About the value of Envelope Crossing Threshold

Question 1)

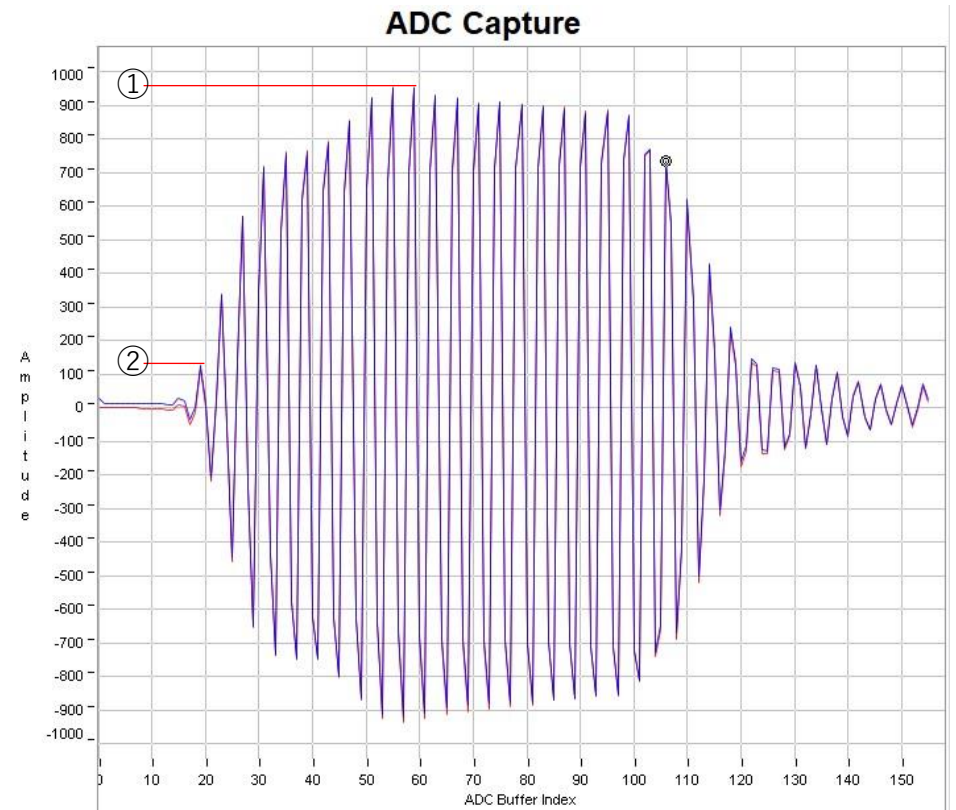
ADCcapture waveforms as shown on the right were obtained with the sensor currently planned to be used.

- ① Amplitude is about 960 at peak
- ② The first wave is about 120

In this case, when determining the threshold in conjunction with the wave in ②, ② is 12.5% of ①.

The value of Envelope Crossing Threshold is less than 12.5, and furthermore, considering the variation of the sensor, we set the value to 10.

Is this concept correct?

Question 2)

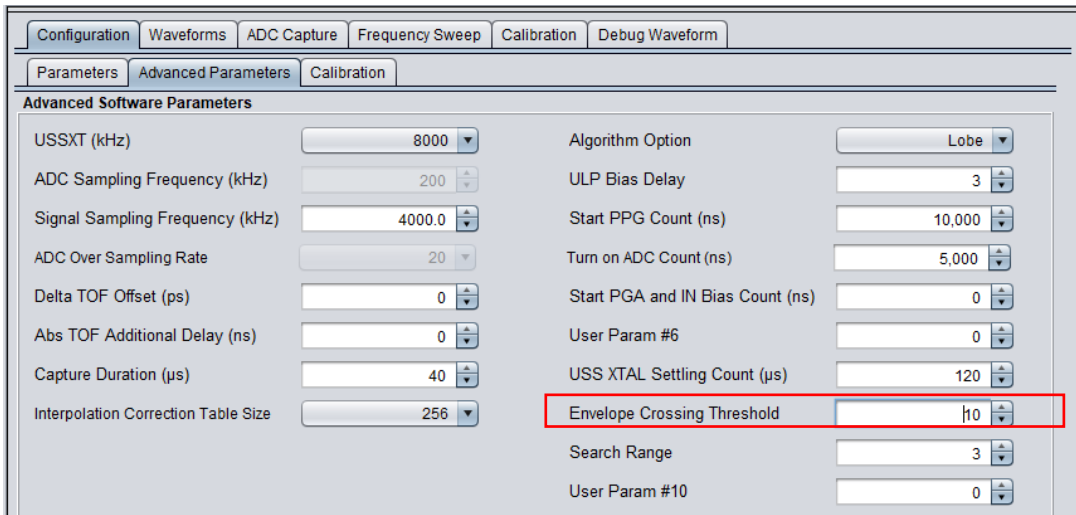
① is an ACDcapture with a flow rate of 1200 l/h.

② is ACDcapture with a flow rate of 0 l/h.

At 0 l/h, there is no difference in amplitude peak between UP and DOWN.

However, at 1200 l/h, there is a large difference in amplitude peak between UP and DOWN.

Is this correct?

I am concerned that if there is a difference in the peak between UP and DOWN, there will be a difference in the threshold position, and therefore the Absolute TOF value will not be correct.

Please let me know your opinion.
